Addendum No. 4
April 29, 2019

Project: **Student Services Phased Renovations – Phase I**
University Student Union
South Dakota State University
Brookings, South Dakota
Project No: 1025.2817.18

1) **DRAWING SHEET 9.10 – FLOOR PLANS - ELECTRICAL**

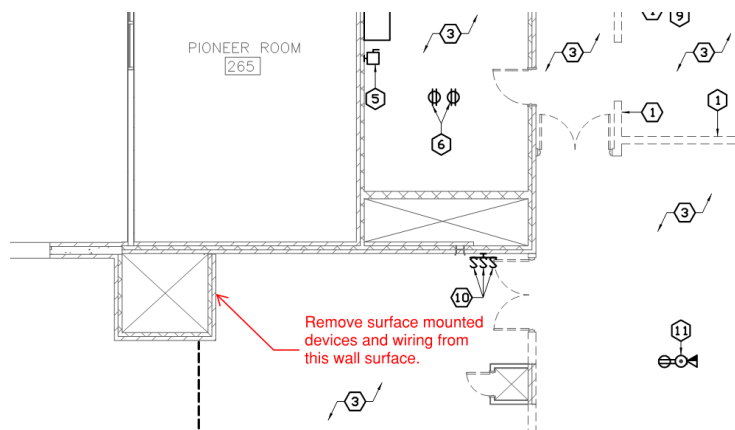
- a) Second Floor Demo Plan – Electrical. Reference the east face of the east chase wall shown below. Remove any/all surface mounted electrical devices and wiring from this surface to make room for new seating that will be built in here.
